SERVICE BULLETIN

ENGINE - FUEL AND CONTROL - INCORPORATE A NEW ELECTRONIC ENGINE CONTROL (EEC)
CONFIGURATION - CATEGORY CODE 4 - MOD.ENG-73-0007

V2500-ENG-73-0007

ENGINE FUEL AND CONTROL - EEC150 ELECTRONIC ENGINE CONTROL
INCORPORATE NEW SOFTWARE

Location of Electronic Engine Control
Fig.1

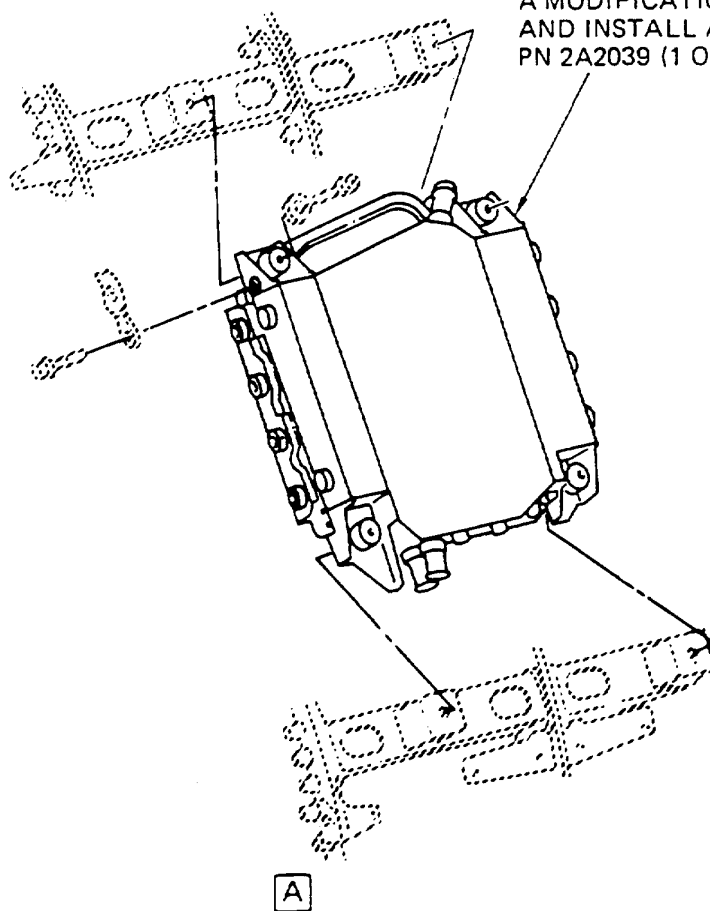
- (1) Remove the PN 2A1988 or 2A1989 RElectronic Engine Control by the approved procedure in Reference (2), Chapter/Section 73-22-34, Removal/Installation. Refer to Figure 1.

REMOVE PN 2A1988 OR
PN 2A1989 ELECTRONIC
ENGINE CONTROL, DO
A MODIFICATION, IDENTIFY
AND INSTALL AS
PN 2A2039 (1 Off)

- (1) Do a modification of the PN 2A1988 or 2A1989 Electronic Engine Control and identify as PN 2A2039 by the approved procedure in Reference (1).

- (1) Install the PN 2A2039 Electronic Engine Control by the approved procedure in Reference (2), Chapter/Section 73-22-34, Removal/Installation.
